Zoning Board of Appeals Staff Report

SUBJECT: ZBA 23-003

PROJECT SITE: 2620 Baseview Boulevard
TID 15-31-401-021

PROJECT: Variance application to permit the construction of an accessory structure within the required 25-foot front yard setback from Baseview Boulevard and encroaching into a regulated wetland (25-foot front yard setback required, Section 36-215; 50-foot setback from a regulated wetland required, Section 36-293).

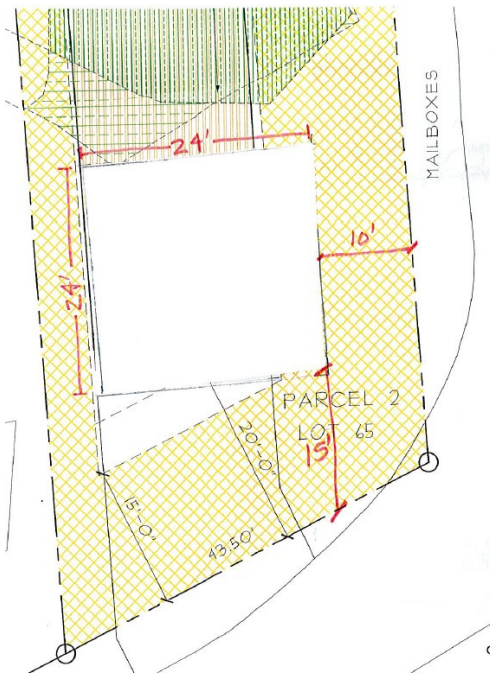
The 50-foot setback from a regulated wetlands applies to the whole of the township. While the State of Michigan does not have a setback requirement from a wetland, the township has made a concerted effort to preserve and protect from undue development pressure the township's wetlands system.

Staff could support a smaller structure with reduced setbacks along Baseview and Maple Vista and offers an alternative placement of a 576-square foot accessory structure as shown below. The structure would have a zero-foot from the wetlands, a ten-foot setback from Maple Vista, and a 15-foot setback from Baseview Boulevard. Staff would defer to EGLE staff for determination of Part 31 and Part 303 permit requirements for this configuration.
